Service Bulletin

CRF450L #1

SAFETY RECALL

2019 CRF450L HORN STAY BROKEN

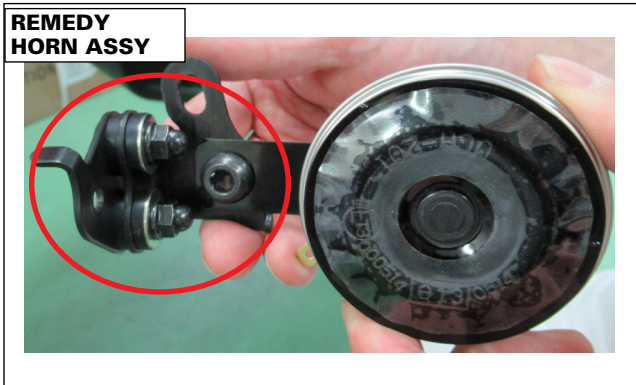
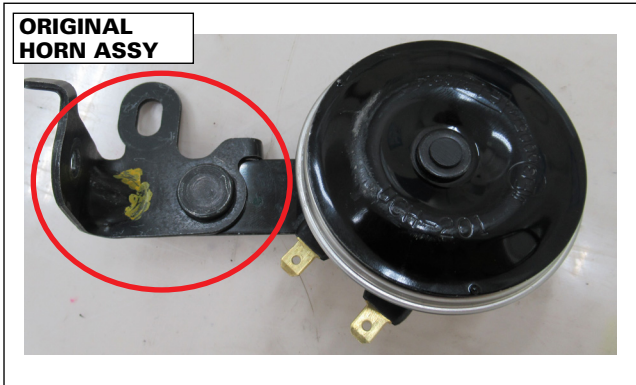
Honda is launching a SAFETY RECALL on **ALL** 2019 CRF450L motorcycles to replace the horn assembly. Under certain conditions, the horn stay can break causing the horn to become loose or fall off.

- If the **remedy** horn assembly (shown below) is currently installed, the recall repair has already been performed. No repair is needed.

- If the **original** horn assembly (shown below) is currently installed, the repair needs to be performed. Continue to the Recall Repair Procedure section.

Honda will provide an improved horn assembly to replace the defective part.

Refer to page 20-23 in the 2019 CRF450L Service Manual to perform the recall repair by replacing the original horn assembly with the remedy horn assembly.

NOTE: There are two new clips for the horn harness included in the remedy parts kit. Use these clips to replace the original clips, if damaged.
